Groundwater Transfer Review Summary Form

Transfer/PA # T- 14400

Application: T-14400

Applicant Name: City of Keizer

Well Location Map

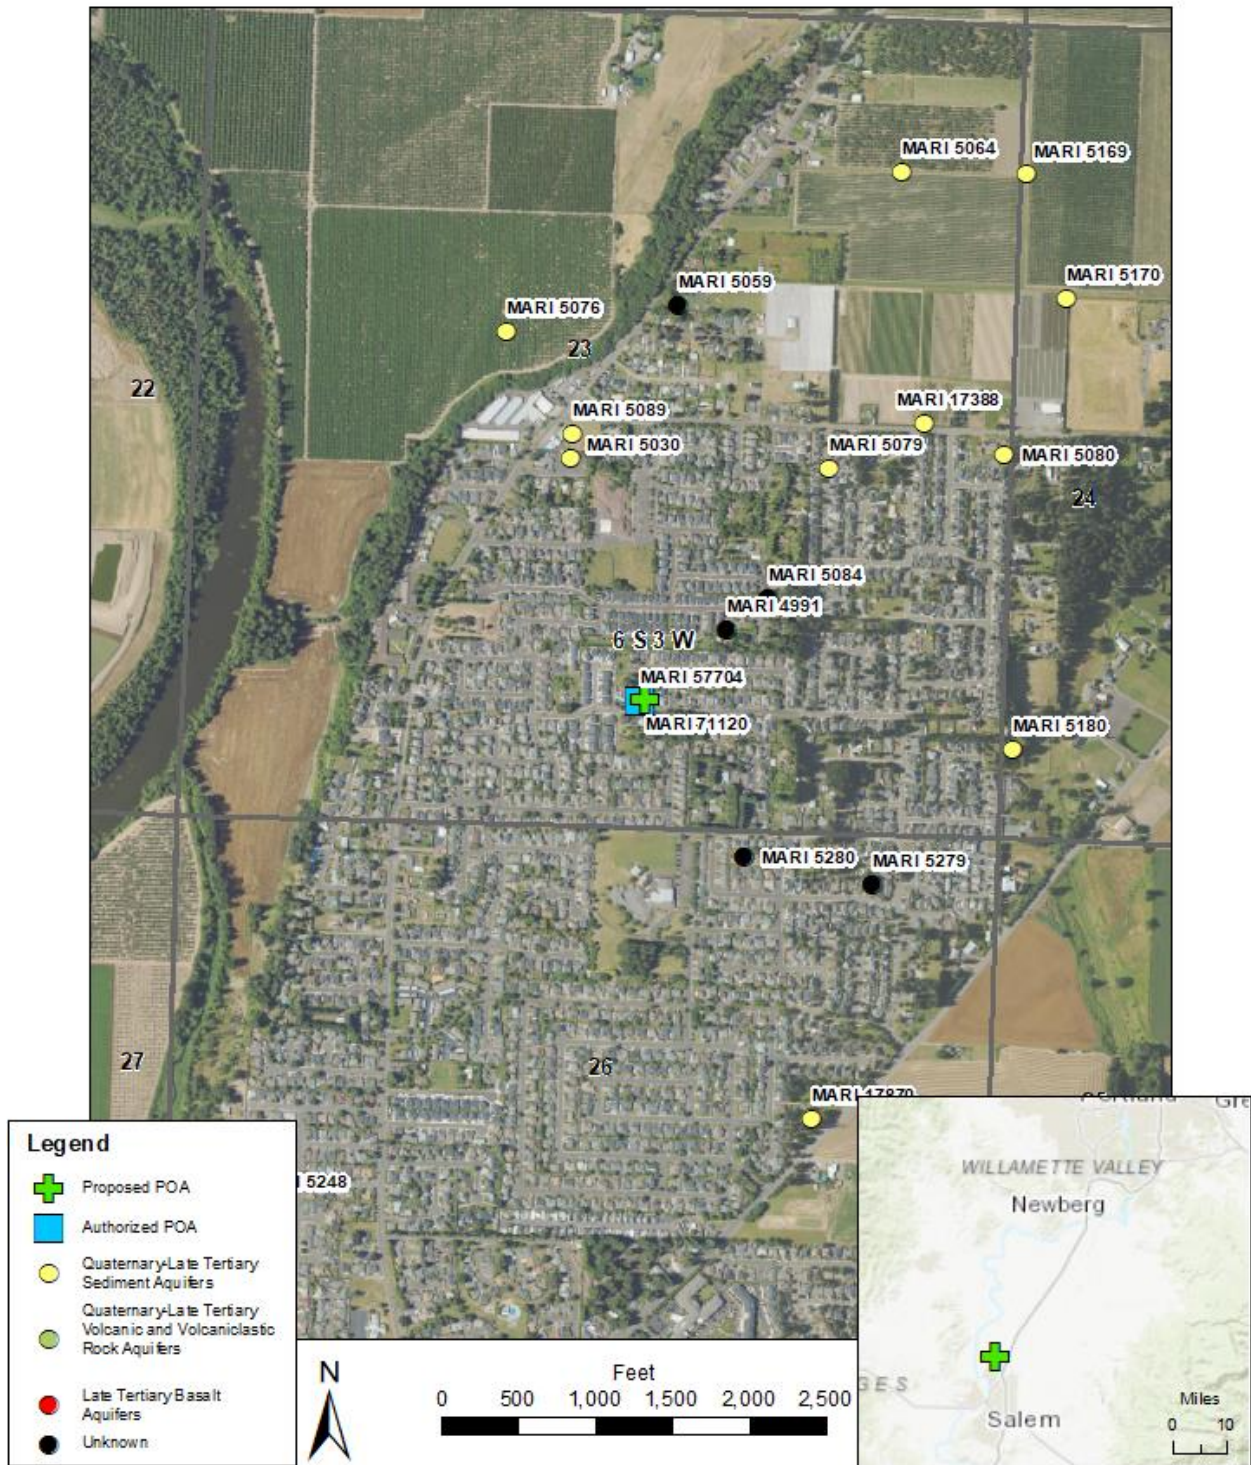
The metes and bounds location descriptions provided in the application for the authorized and proposed POAs are incorrect. For this review, the location of MARI 57704 is assumed to be 880 feet north and 2,320 feet west from the SE corner of section 23, as listed on Permit G-15369. Based on GPS coordinates collected during OWRD well inspection, the proposed POA (MARI 71120) is located approximately 40 feet to the northeast of the authorized POA (MARI 57704).

4. a) Will this proposed change, at its maximum allowed rate of use, likely result in an increase in interference with **another ground water right**?
 Yes No Comments: The proposed POA is located approximately 40 feet from the authorized POA and is not appreciably closer to other groundwater rights. The proposed change is not likely to result in an increase in interference with another groundwater right.

5. a) Will this proposed change, at its maximum allowed rate of use, likely result in an increase in interference with **another surface water source**?
 Yes No Comments: The proposed POA is located approximately 40 feet from the authorized POA and is not closer to a surface water source. The proposed change is not likely to result in an increase in interference with a surface water source.
